Editor's Summary of Comments Against Clause 69, Annexes 69A and 69B

Adam Healey
Agere Systems

Comment #210 Considerations

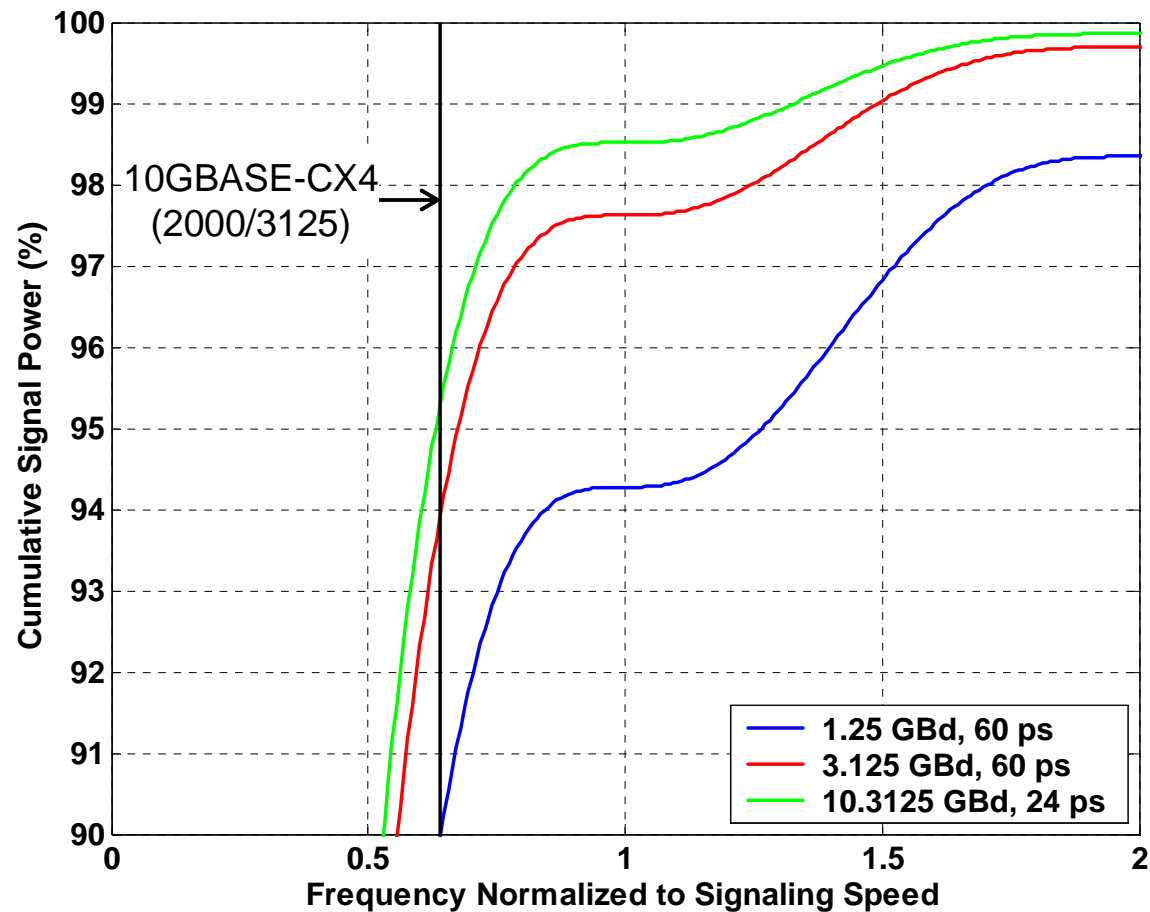
- Delete Annex 69A (#210)
 - Valid only if the channel completely specified and requirements are normative
 - Proposed text (clause 72 examples):
 - *The receiver shall operate with a BER of better than 10^{-12} when receiving a compliant transmit signal, as defined in 72.7.1, though a compliant backplane channel as defined in Annex 69B.*
- Add swept-sinusoid jitter tolerance (#260)?

- Pro's
 - Link closes by definition
 - Considers the entire channel space, rather than a singular corner case (worst-case) link
 - If accepted, #263, 63, 100, 232, 211, 216 overtaken by events
- Con's
 - Lack of well-defined test procedure yields inconsistent test methodologies and results

Cumulative Signal Power vs. Frequency

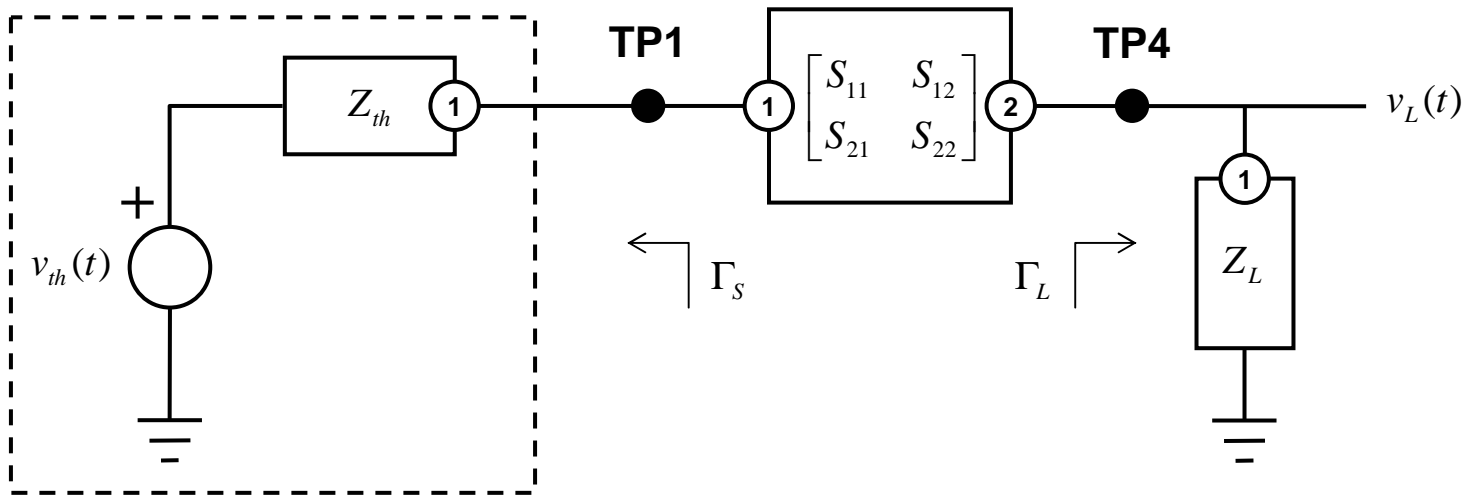
- Channel parameters should be specified over a range of frequencies representing the occupied bandwidth of the PHY of interest
- The occupied bandwidth can be related to the signaling speed and the minimum transition time of the PHY.
